# PD Modification Application: MM 25-0265

Development Services Department

The applicant is requesting a major modification to PD 85-0206 (as most recently modified by MM 92-0133) to allow an existing shopping center to be redeveloped with up to 228,000 square feet (SF) of retail space, which would include up to 181,000 SF of large-scale retail development.

# SITE PLAN "100"

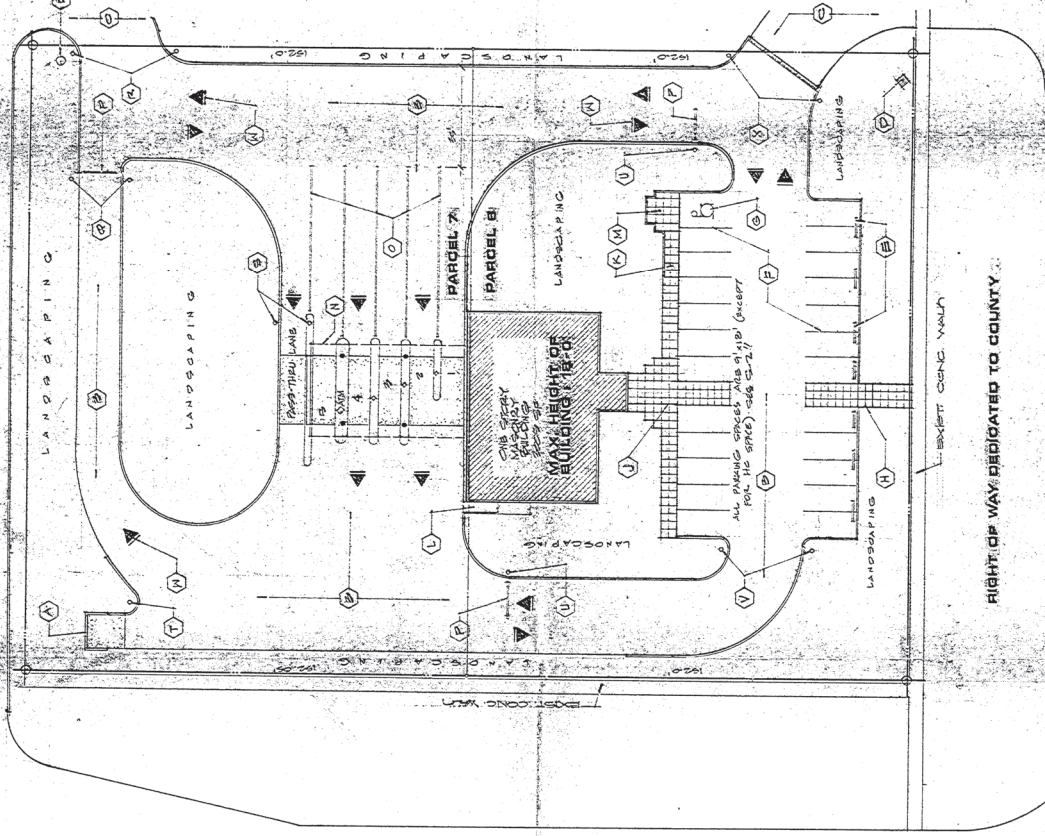
1. Remove the current Sheet 1; (2) revise the retail summary table as shown on Sheet 2; (3) show the modification area on Sheet 2 and include a note to see Sheet 3 of 3; (4) identify Sheet 2 as Sheet 1 of 3; and (5) label the proposed site plan as Sheet 3 of 3.

Figure 2: Access Spacing

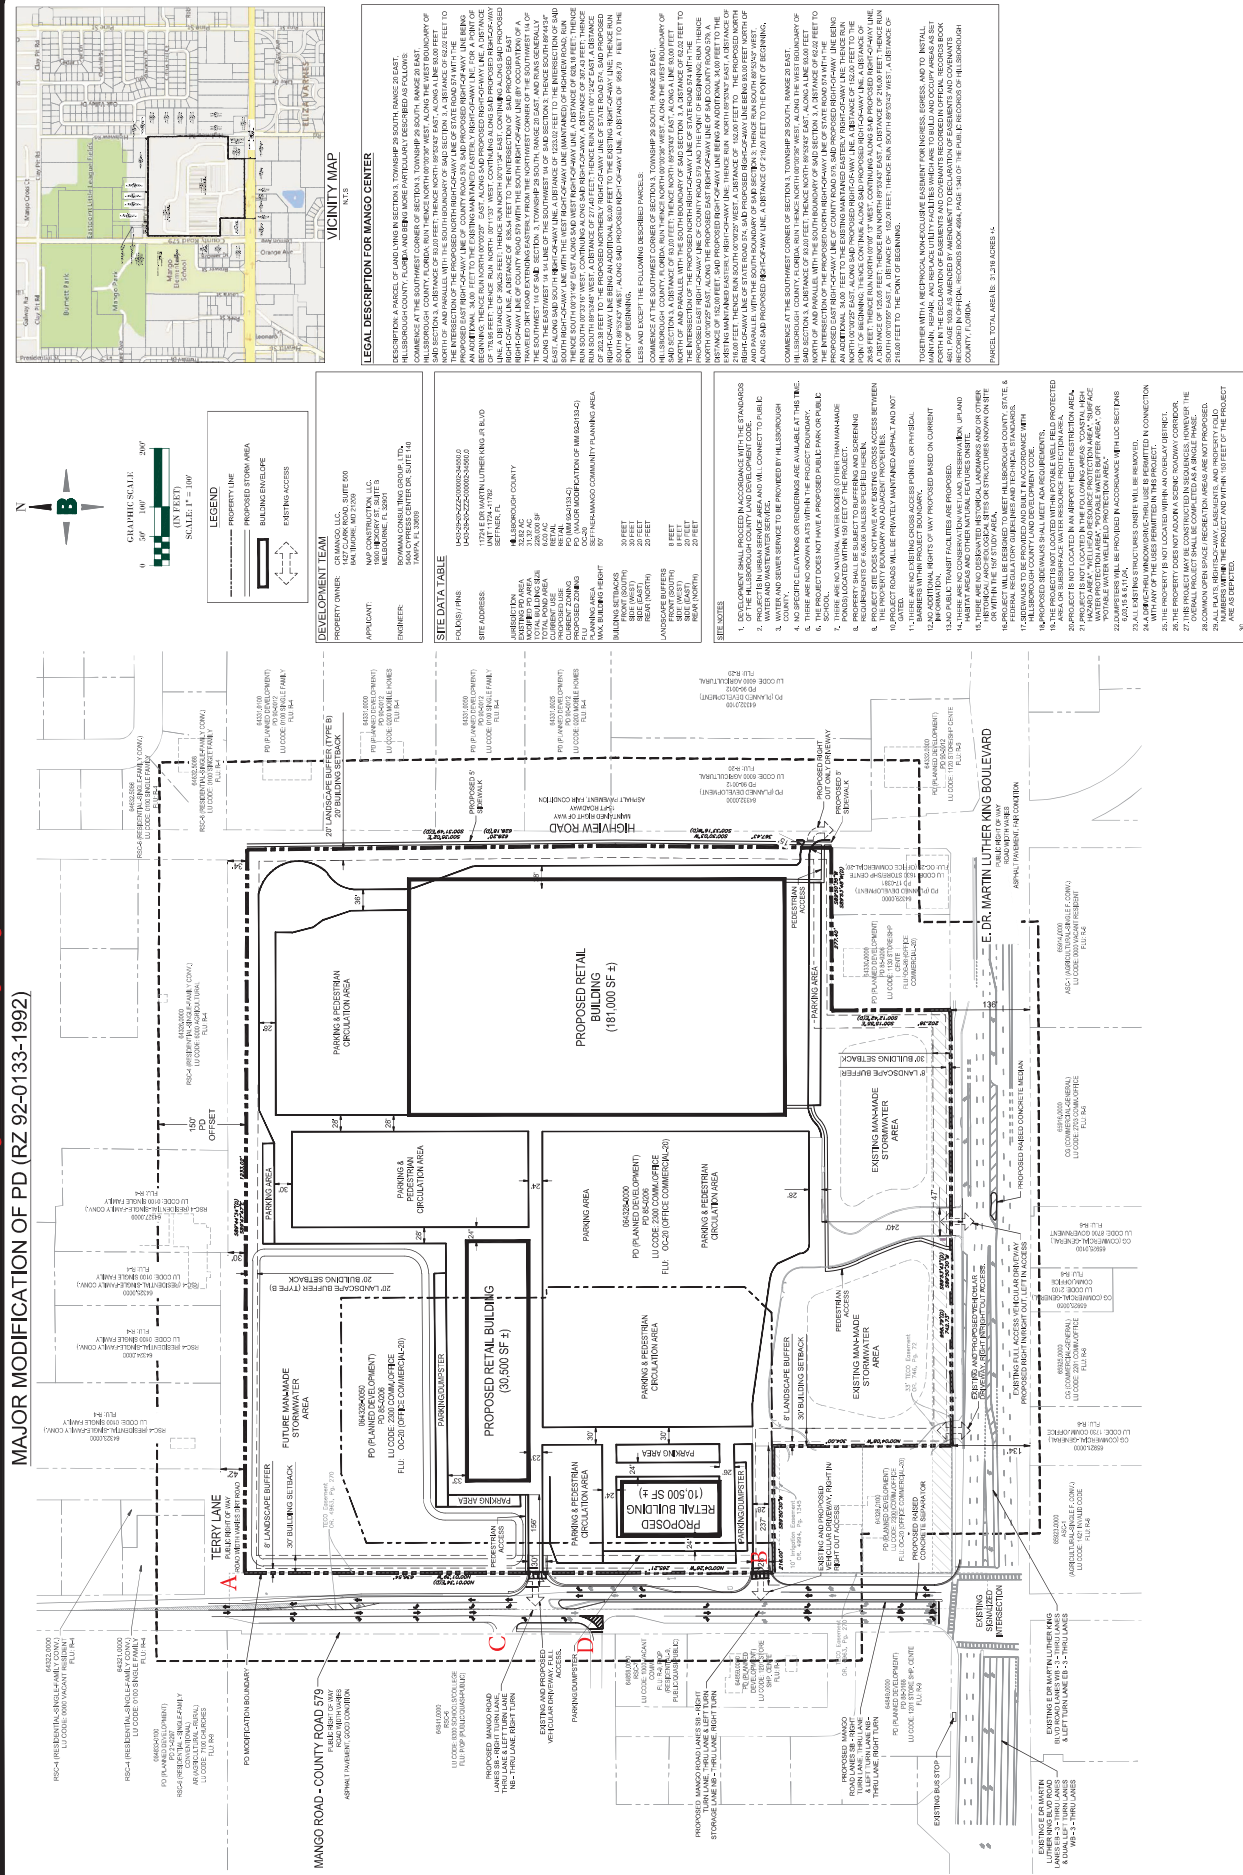
The request is to maintain the existing access locations that have served this project for over 30 years. With the introduction of a raised median, the southern access on Mango Road will meet the connection spacing standard of 245 feet. However, while the northern access meets the connection spacing standard of 245 feet for driveways on the east side of Mango Road, there are two driveways (noted as C and D in Figure 2) on the west side of Mango Road that serve the existing school that do not meet the connection spacing standard. The existing driveway

The existing full access to the project, is approximately 15 feet south of the existing driveway to Mango Elementary front entry (noted as Driveway C in Figure 2). This access point has relatively low traffic volumes and is not the primary parent pick-up and drop-off location, which is the driveway to the south (noted as Driveway D in Figure 2). To minimize the conflict to the two Mango Elementary School driveways west of the primary full access to the project, the application will extend the southbound right turn lane on the west side of Mango Road, to allow for the existing right turn lane to serve both the main entrance driveway and also the parent pick-up/drop-off right-in only driveway. Given the Mango Elementary School layout, the historic operation of the project driveway and the proposed improvement to the Mango Elementary driveway, the driveway spacing would not be detrimental to the public health, safety and welfare of the motoring public.

Figure 2: Proposed Typical Sections

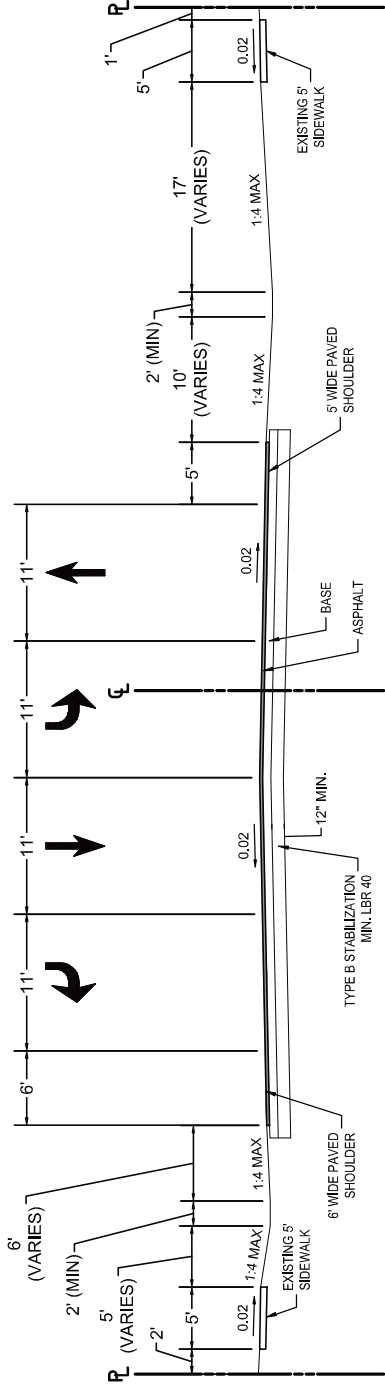
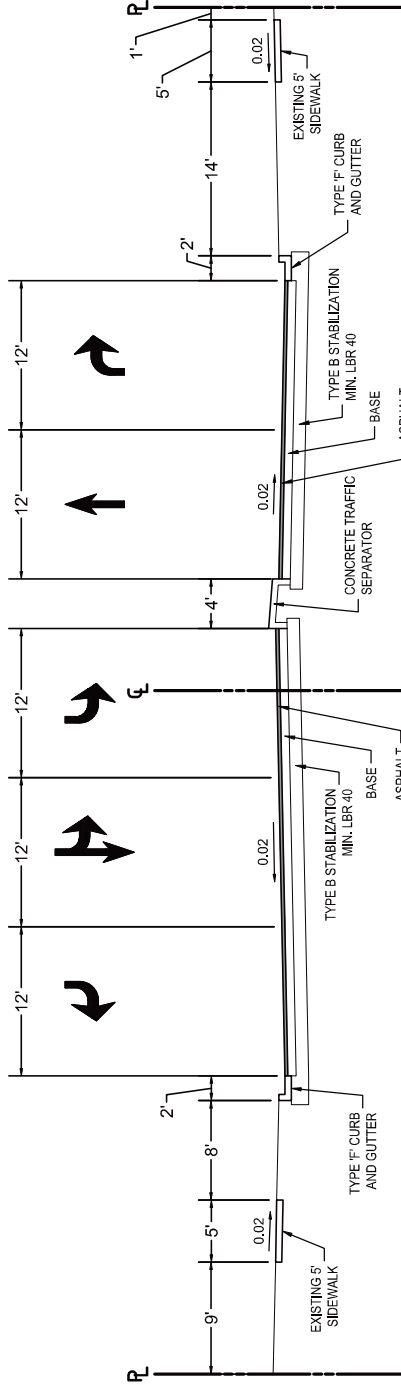
Based on the proposed plan, the internal throat depth is 156 feet. In addition, a northbound right turn lane and southbound left turn lane will be provided that will also allow entering vehicles to move out of the through traffic on Manago Road. Per discussions with staff, the northbound right turn lane has been agreed to be extended to provide approximately 80 feet of additional length (approximately 265 feet overall). These turn lanes provide additional assurance that the entering project traffic does not impact the through traffic on Mango Road. Given the information outlined in this section, the proposed throat depth would not be detrimental to the public health, safety and welfare of the motoring public.

Figure 2: Proposed Typical Sections

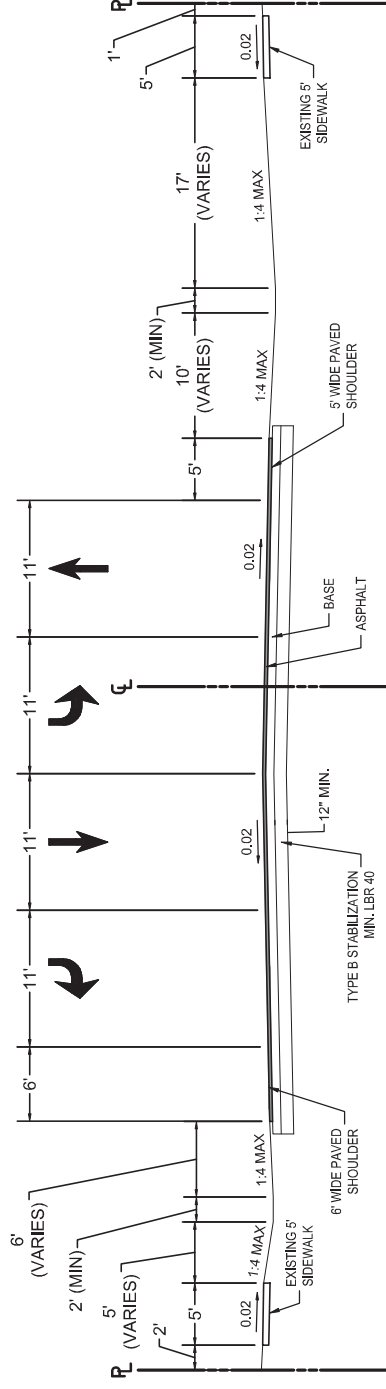
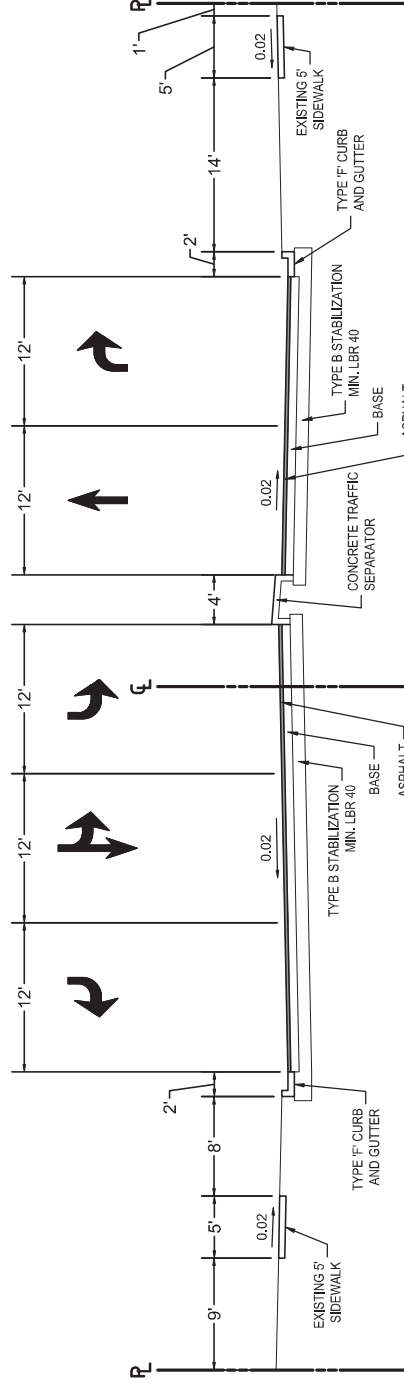
This request is a design exception to the Hillsborough County Transportation Technical Manual for Mango Road from the southern driveway to the northern property line. The requested exceptions to the TS-7 typical section and the justification are as follows:

1. The request is to provide 11-foot travel and turn lanes instead of the 12-foot lanes. According to the Florida Green Book, on a suburban roadway where the speed limit is between 40 and 45 mph, 11-foot lanes may be used. The post speed limit on Mango Road is 45 mph.
2. Provide an 11-foot wide, 285-foot-long southbound left turn lane at the project northern driveway. The length includes a 50-foot taper.
3. Provide an 11-foot wide, 250-foot-long northbound right turn lane at the project northern driveway. The length includes a 50-foot taper.
4. The open drainage will be reduced in width from the 19 feet identified in the TS-7 but will maintain the maximum 1:4 side slope.
5. The 5-foot paved shoulder is being provided on the east side of Mango Road. However, the existing paved shoulder on the west side of Mango Road is approximately 3 feet, which will remain unchanged.
